CERTIFICATE OF APPROPRIATENESS

Property: 201 W. 15th Street, Lot 11, 12, & 13, Block 142, Houston Heights Subdivision. The property includes a historic two-story wood framed single-family residence and a garage apartment with attached CMU shop building situated on a 13,200 SF corner lot.

Proposal: Alteration – Signage

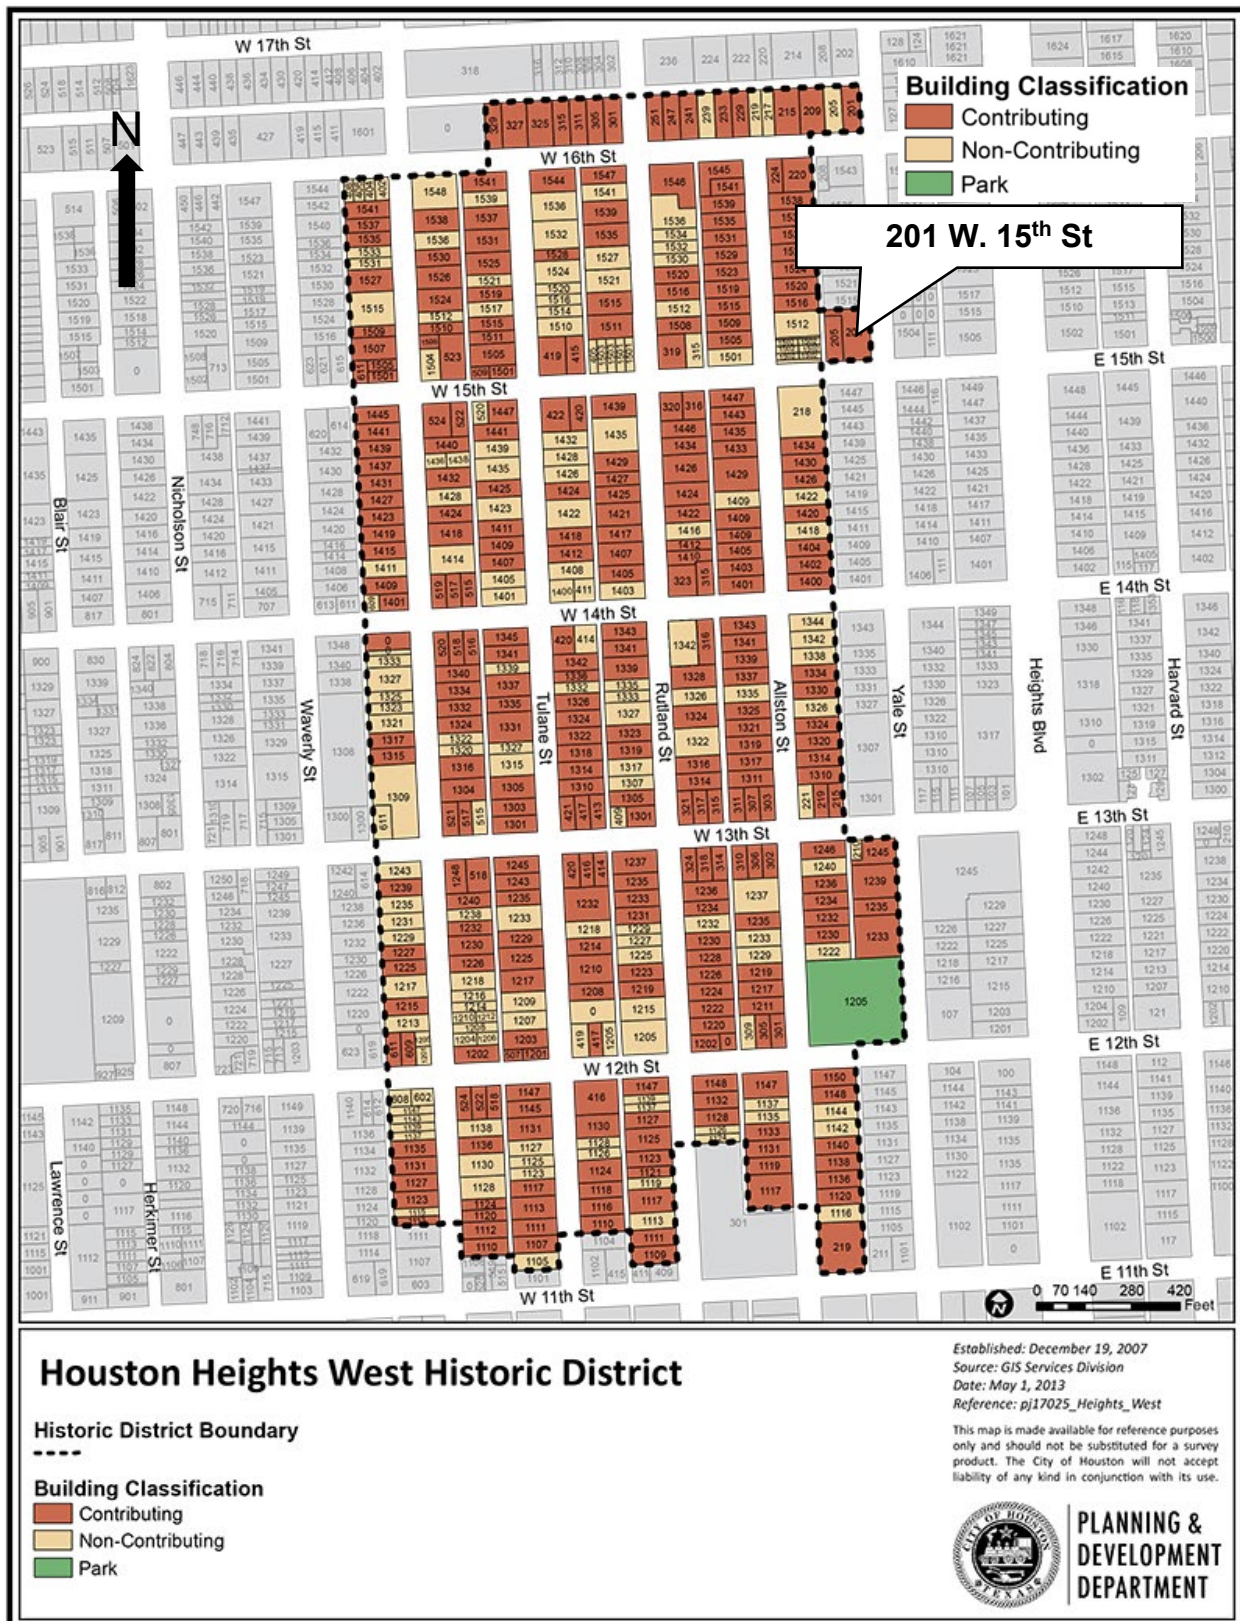
<input type="checkbox"/>	<input type="checkbox"/>	<input type="checkbox"/>	In accordance with Sec. 33-276, the proposed activity must comply with the City Council approved Design Guidelines. <i>The current design is internally illuminated, which violates Section 4.77 of the Heights Design Guidelines. Will meet Heights Design Guidelines with the Approval with Conditions.</i>
--------------------------	--------------------------	--------------------------	--

Recommendation: Approval with conditions: that the sign be illuminated indirectly.
